Comparison between exhibited version (31 July 2017) and exhibited version (18 September 2017) Additions shown in blue Deletions shown in red

### SCHEDULE 12 TO CLAUSE 43.04 DEVELOPMENT PLAN OVERLAY

### **GRONN PLACE, BRUNSWICK WEST**

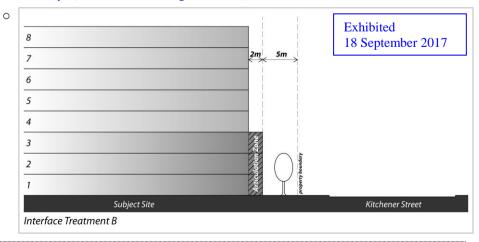
- Buildings that do not encroach within the following building setbacks:
  - Interface Treatment A (Direct Residential Interfaces) 3m boundary setback boundary setbacks as shown on the Development Concept Plan and increased as required to protect existing trees to be retained or accommodate replacement canopy trees and to comply with Clause 32.04-9;
  - Interface Treatment B (Kitchener Street) 4.5m street setback up to 3 storeys and an additional 3m setback above 3 storeys (as shown in the diagram below);

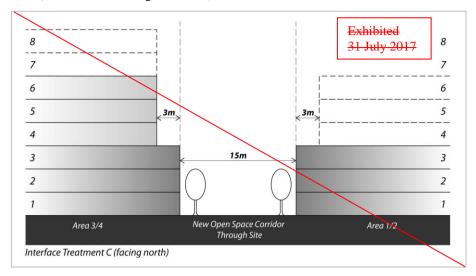
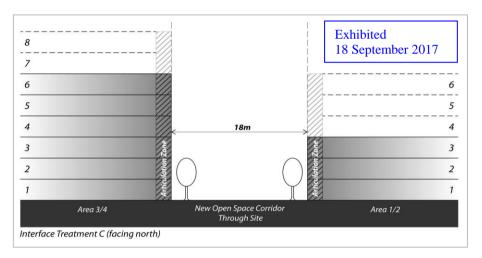
Interface Treatment B (Kitchener Street – northern portion) – 5m street setback with articulation zone up to 3 storeys and an additional 2m setback above 3 storeys (as shown in the diagram below);

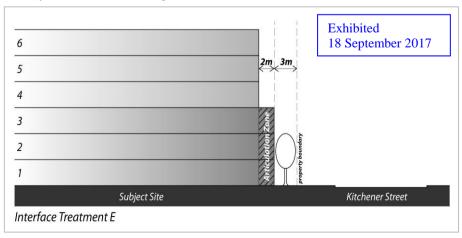
Interface Treatment C (New Open Space Corridor Through Site) – 3m setback for portions of buildings above 3 storeys-18m wide corridor plus a 2m articulation zone (as shown in the diagram below); and
